From: Hon, Andrew
Sent: Friday, February 23, 2018 3:20 PM
To: Thompson, Russell R
Subject: Request For Additional Information Related to TVA Fleet Topical Report TVA-NPG-AWA16 – EPIC: L-2016-TOP-0011)
Attachments: TVA ssPMP TR RAIs_02222018_final.docx

Request for Additional Information

Topical Report TVA-NPG-AWA16, "TVA Overall Basin Probable Maximum Precipitation and Local Intense Precipitation Analysis, Calculation CDQ0000002016000041"

Operating Company: Tennessee Valley Authority

Figure 1. Comparison of Smethport OTF using TVA's rescaling approach (left) and original approach (right) for TRANS=1 grids (i.e., transpositionable zone)

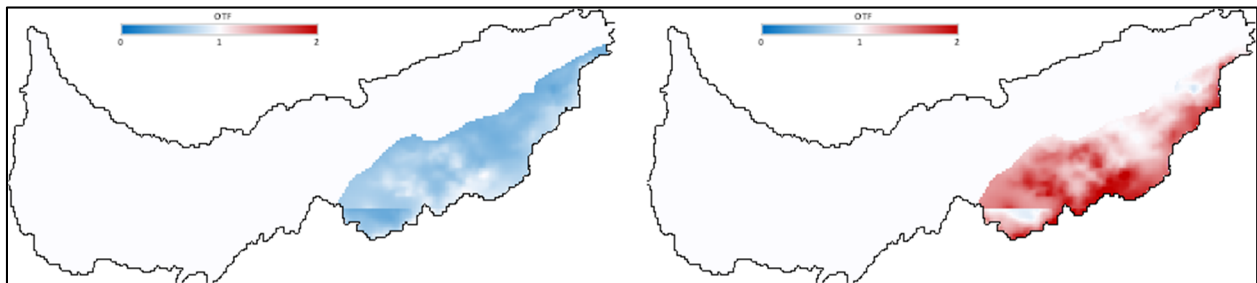
Staff's review of the data provided by the licensee suggests that the maximum original (i.e., unadjusted) OTF values for the Smethport and Simpson events are 2.15 and 2.09, respectively. In comparison, the average Zone 4 original OTF is 1.39 for Smethport and 1.35 for Simpson. After rescaling the original OTF, the average Zone 4 OTF is reduced to 0.66 for Smethport and 0.65 for Simpson – approximately a 50% reduction. These modifications to the OTF result in a significant reduction in the adjusted DAD values for these storms. In addition, since these storms control PMP estimates, the resultant PMP values are significantly reduced.

Figure 1 provides a comparison of TVA's rescaled OTF values and the original (i.e., unadjusted) OTF values for the Smethport storm. Similarly, Figure 2 provides a comparison of TVA's rescaled OTF values and the original OTF values for the Simpson storm.

Provide justification for adjusting the Smethport, PA and Simpson, KY OTF values to a maximum of 1.00, and for using significantly reduced OTF values throughout the transpositionable zone.

Figure 3. Regional groupings for daily data used to prepare NOAA Atlas 14 Volume 2

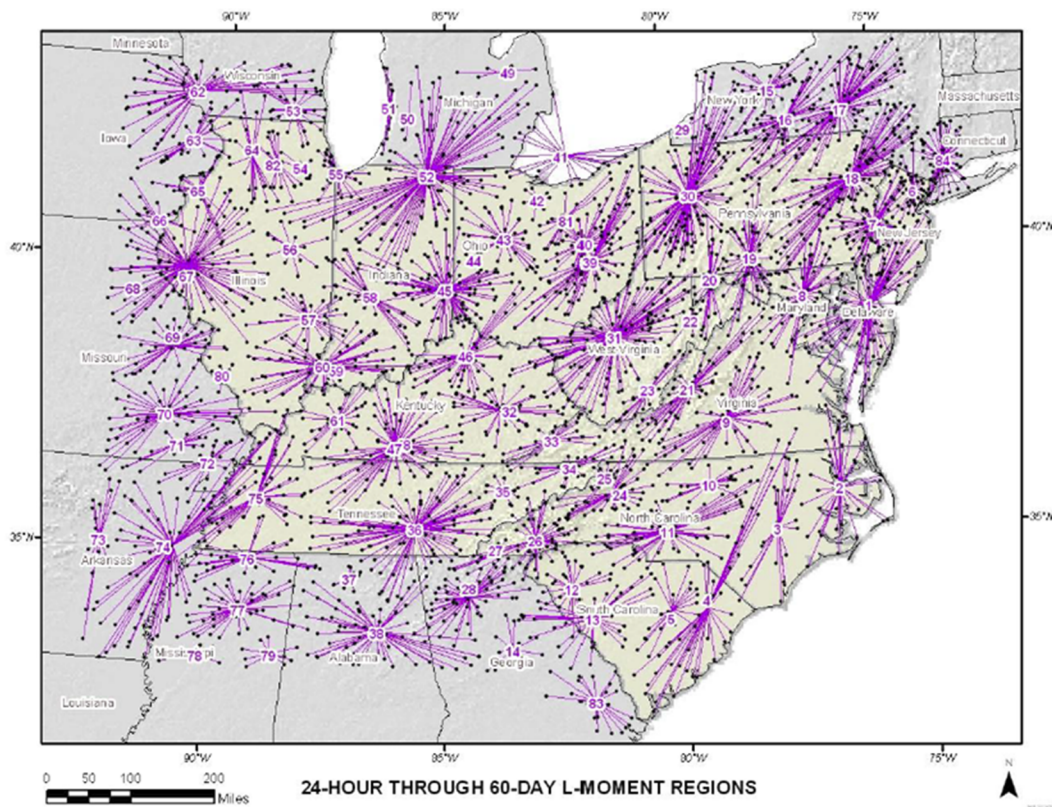
However, during the development of the PF data, Atlas 14 identified homogeneity zones (i.e., regional groups) for data pooling. Based on Section 4.2.2 of Atlas 14, Volume 2, the regional application of L-moments derives *“the shape parameters from all stations in a homogeneous region rather than from each station individually.”* From Section 4.4 of Atlas 14, Volume 2: *“effort was made during the subdivision process to mitigate discrepancies that could be caused by (1) sampling error due to small sample sizes, or (2) regionalization that does not reflect a local situation.”* Figure 3 shows the 24-h through 60-day regional groupings identified in Atlas 14, Volume 2.

Generally speaking, all precipitation data within a homogeneity zone were first locally normalized, and then pooled together for probabilistic density function fitting. Therefore, it is important to understand that the NWS Atlas 14 values do not only capture the local precipitation features. It is jointly influenced by the local mean (of annual maximum series at each gauge), regional probability density distribution, and final interpolation by PRISM.

- a) Considering Atlas 14's regional features, provide a justification regarding whether the Atlas 14 PF data represent reasonable spatial variation representative of orographic PMP effects or PMP in general.
- b) Provide a justification for using the best fit linear trend method in lieu of the 100-y ratio method for determining LIP and basin-wide PMP values.

Figure 4: Grid cells for which OTF calculation used an absolute cell reference value for General & Tropical storms (the red grid cell indicates the location of the grid cell used for assigning an OTF value for all yellow colored grid cells)

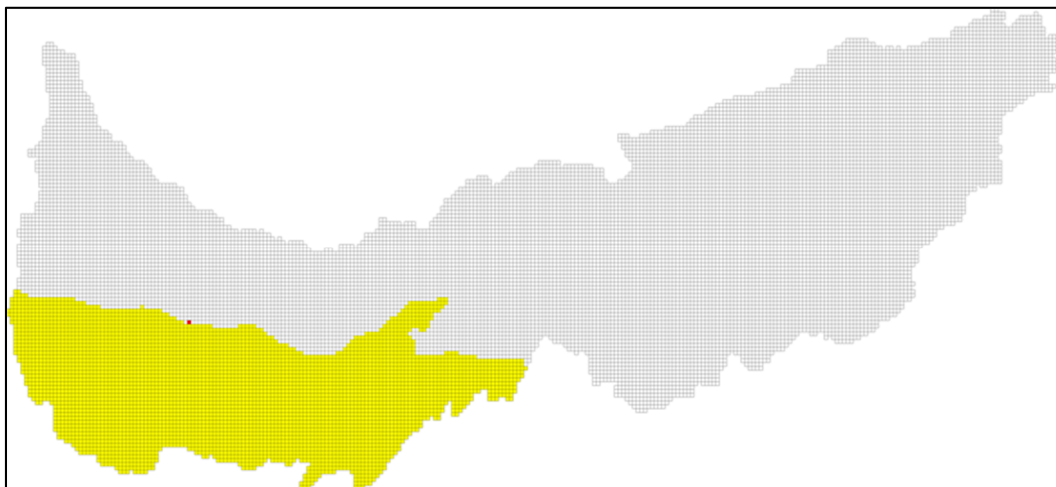
Staff's review of the Total Adjustment Factor (TAF) Excel files provided in response to RAI #1 revealed some anomalies in how the OTF was calculated. For a select set of grid cells, the OTF was calculated using an absolute cell value in the Excel spreadsheet rather than using the OTF regression-based formula used in other cells. Visualization of the areas using the absolute cell reference value is provided in Figure 4 (for general and tropical storms) and Figure 5 (for local storms).

- a) Provide an explanation for why the OTF was calculated using an absolute cell reference value for the grid cells identified in Figure 4 and Figure 5 rather than using the OTF regression-based formula used for the other cells.
- b) Provide an explanation for why the OTF values provided in RAI #1 and RAI #3 differ, as illustrated in Figure 6.

Figure 6: Grid cells (in red) for which OTF differs between RAI #1 & RAI #3 for Local storms

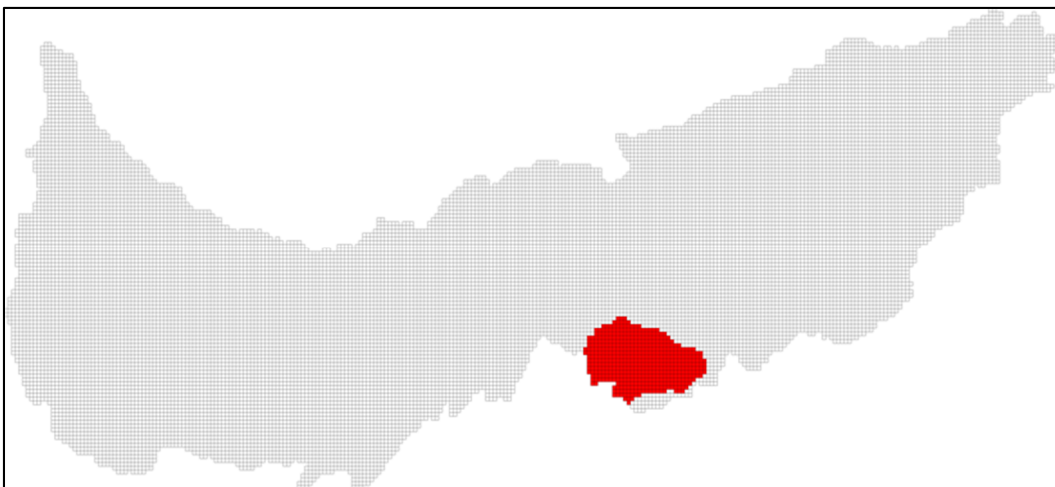
In addition, staff compared the Excel-based OTF values from the RAI #1 response and the GIS-based OTF values from RAI #3. The comparison revealed a discrepancy in calculated OTF values for local storms which was confined to a region of the southern Appalachians. Visualization of the areas affected by this discrepancy is provided in Figure 6.

Figure 7. General Storm, SPAS 1206 (Big Rapids, MI) rainfall mass curve (left) and dew point analysis (right)

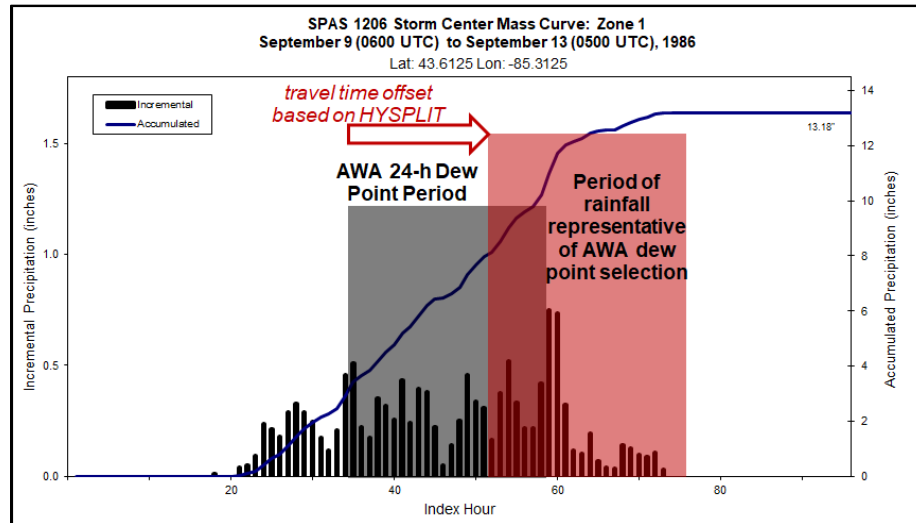
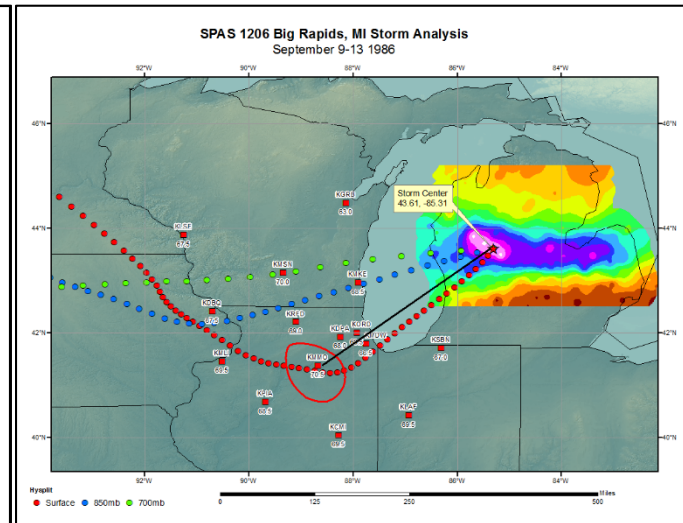
1. General Storm, SPAS 1206 (Big Rapids, MI) – see Figure 7
 - a. The licensee's dew point temperature observations correspond to a period after significant rainfall had already occurred. The representative dew point location is approximately 230 miles SW of the storm center location.

Request: Provide justification for the selection of storm representative dew point values for the above storms with respect to timeframe and location selected, especially considering the timeframe of when rainfall occurs at the storm center. If corrections are warranted, provide an updated analysis as it may affect TVA's 3 NPP sites.

Figure 8. General Storm, SPAS 1208 (Warner Park, TN) rainfall mass curve (left) and dew point analysis (right)

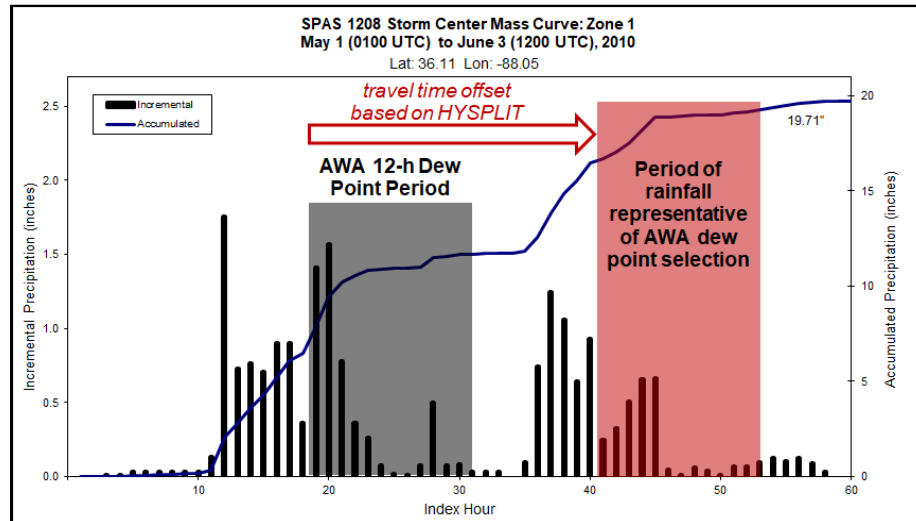
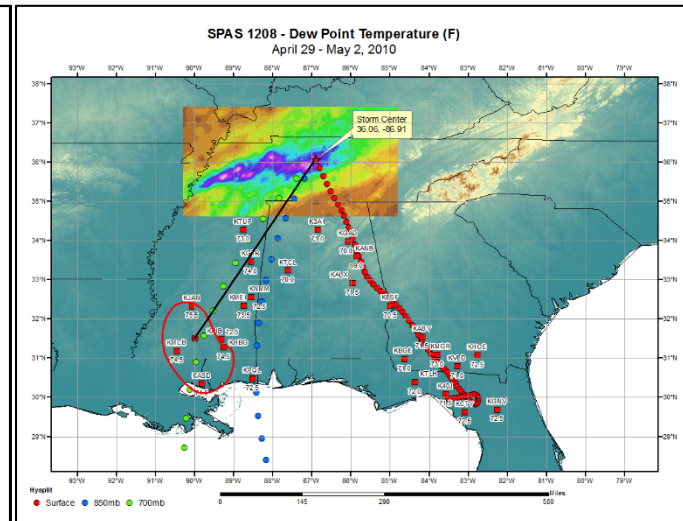
2. General Storm, SPAS 1208 (Warner Park, TN) – see Figure 8
 - a. The licensee's dew point temperature observations correspond to a period when the most intense rainfall occurred. The representative dew point location is approximately 360 miles SSW of the storm center location.

Figure 9. Tropical Storm, SPAS 1276 (Wellsville, NY) rainfall mass curve, dew point analysis, TVA HYSPLIT, and NRC HYSPLIT (from top-left to bottom-right)

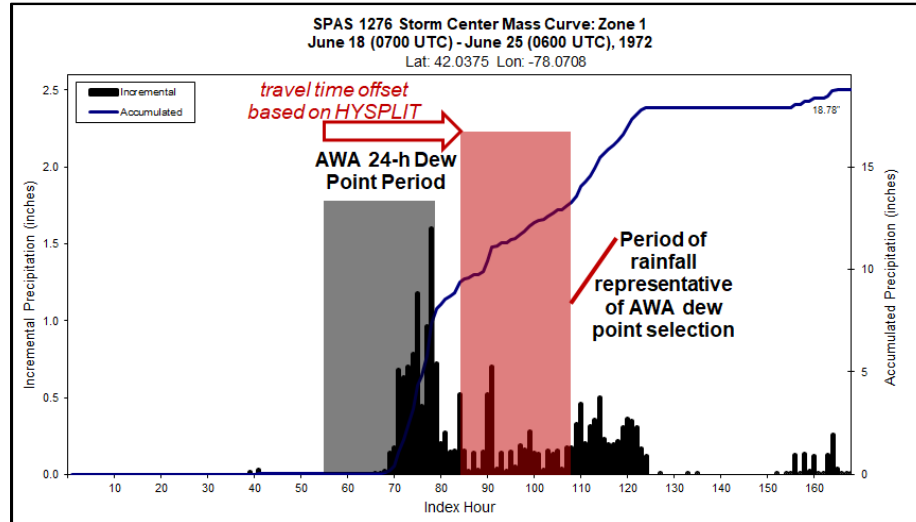
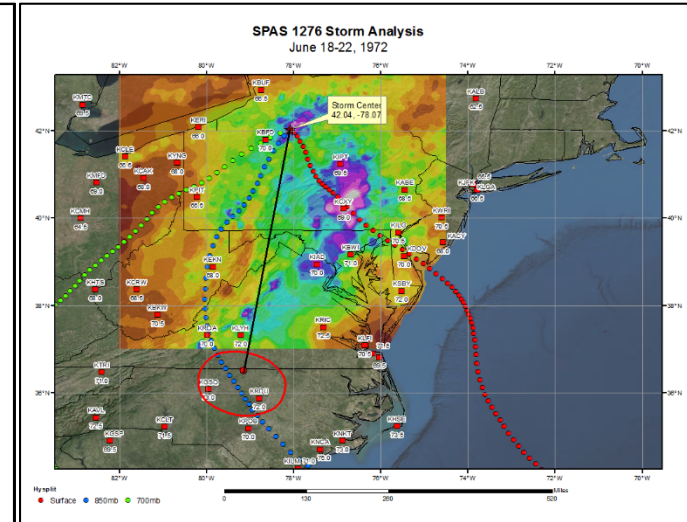
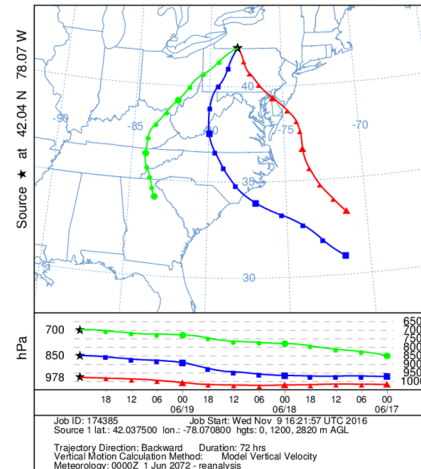
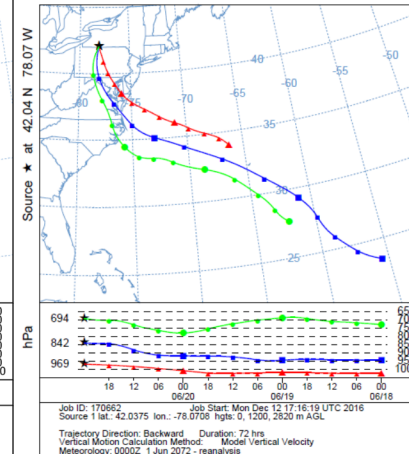
3. Tropical Storm, SPAS 1276 (Wellsville, NY) – see Figure 9
 - a. The licensee's dew point temperature observations correspond to a period when the most intense rainfall occurred. The representative dew point location is approximately 385 miles SSW of the storm center location.

- b. By adjusting the HYSPLIT backward trajectory timing to more closely align with the onset of rainfall, staff identified a moisture inflow direction of SE rather than SSW.

Figure 10. Tropical Storm, SPAS 1317 (Americus, GA) backwards HYSPLIT trajectory from TVA (left) and NRC (right)

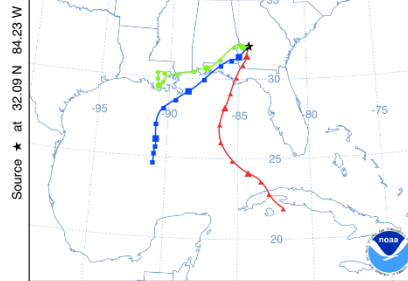
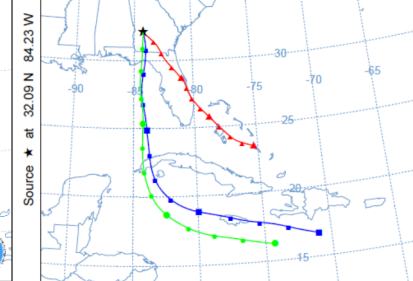
4. Tropical Storm, SPAS 1317 (Americus, GA) – see Figure 10
 - a. By adjusting the HYSPLIT backward trajectory timing to more closely align with the onset of rainfall, staff identified a moisture inflow direction of SE-to-S rather than WSW.

Figure 11. General Storm, SPAS 1218 (Douglasville, GA [shown] & LaFayette, GA) rainfall mass curve (left) and dew point analysis (right)

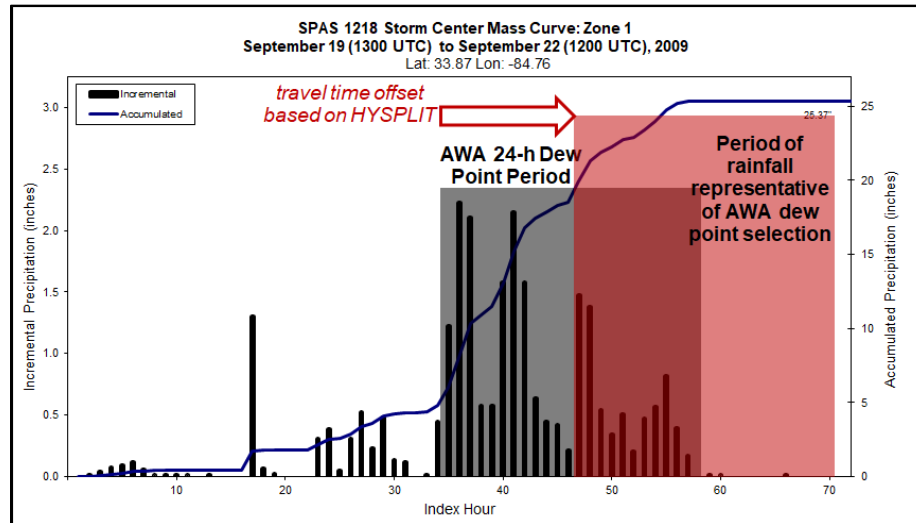
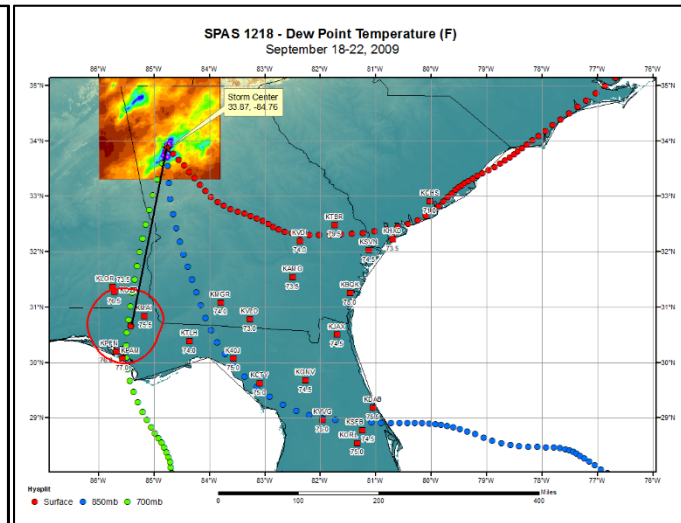
5. Additional storms which exhibit timeframe issues but do not control PMP
 - a. General Storm, SPAS 1218 (Douglasville, GA & LaFayette, GA) - Figure 11

Figure 12. Local Storm, SPAS 1226 (College Hill, OH) rainfall mass curve (left) and dew point analysis (right)

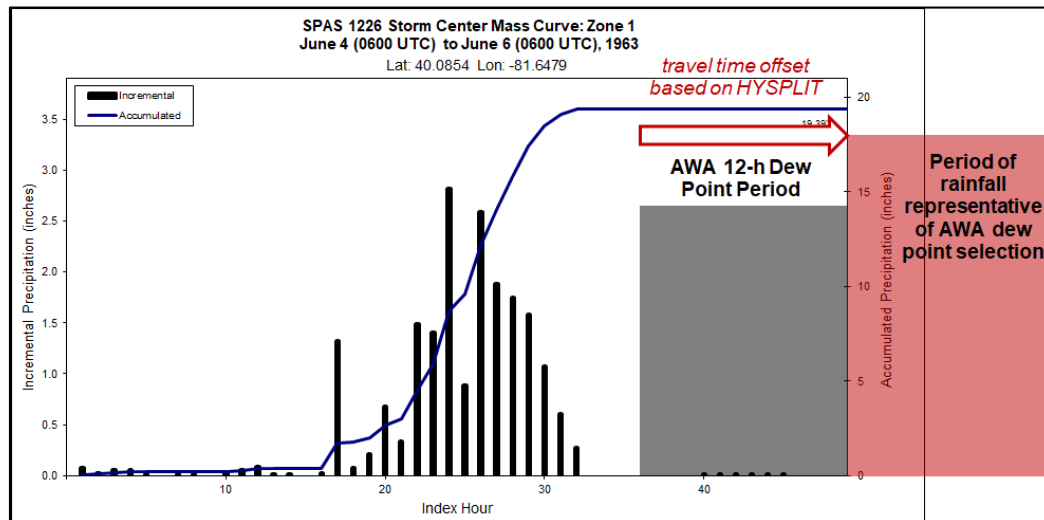
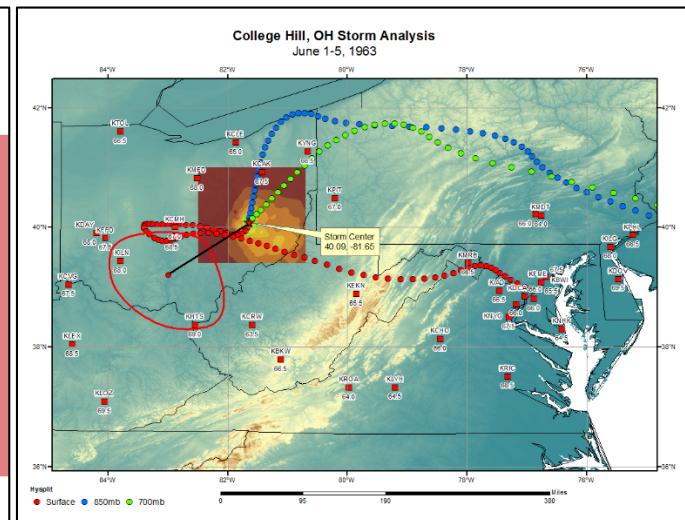
- b. Local Storm, SPAS 1226 (College Hill, OH) - Figure 12
 - c. Local Storm, SPAS 1209 (Wooster, OH) - Figure 13
 - d. Tropical Storm, SPAS 1182 (Larto Lake, LA) - Figure 14

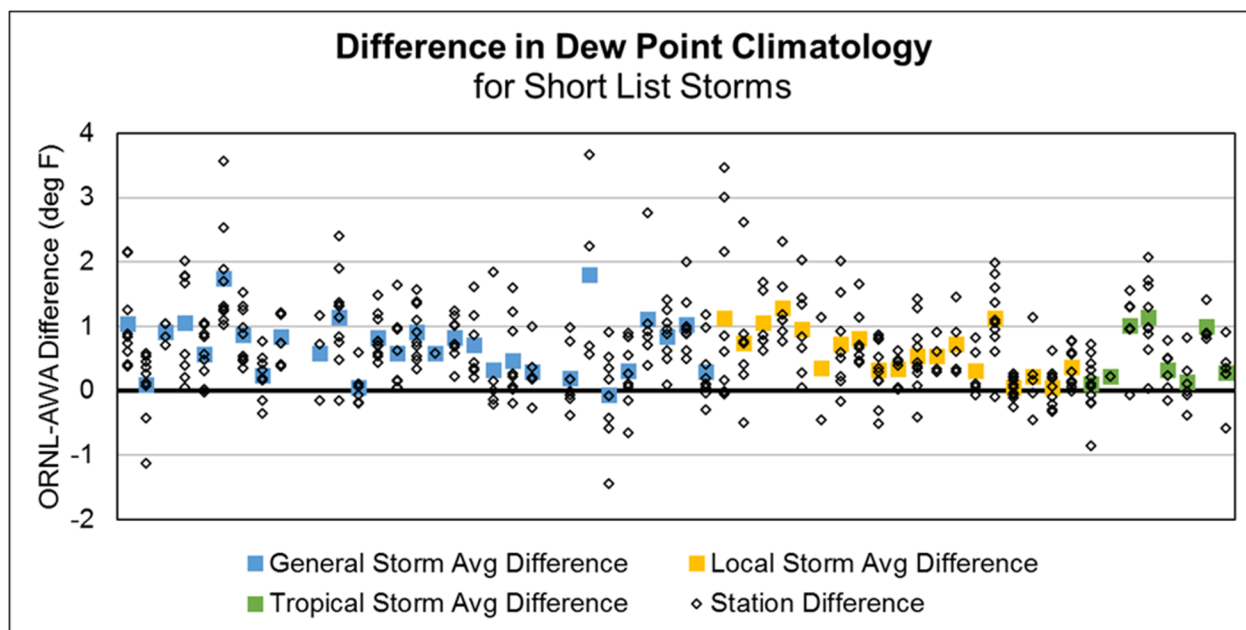
Figure 15 shows the difference in the NRC and TVA dew point climatology values for each comparable station for all short list storms. The stations selected represent the stations which would have most influenced the dew point climatology at the transpositioned moisture source location and for which climatology values were available from both the TVA and NRC data sets. Positive values indicate that NRC's evaluation resulted in higher dew point climatology values than TVA, while negative values indicate that NRC's evaluation resulted in lower dew point climatology values than TVA. On average, the difference for General, Local, and Tropical storms is +0.69 F, +0.61 F, and +0.52 F, respectively, with an overall average station difference of +0.65 F. Individual station differences range from -1.44 F to +3.67 F.

The deviations in climatology values resulting from the two analyses indicates a systematic bias in the overall values, with NRC's values typically 0.5 to 1.0 degree F higher than TVA's values.

Given the significant impacts noted above please update the dew point climatology using TD3505 dew point data and revising both the LIP and basin-wide PMP values accordingly or provide a justification for not updating it.
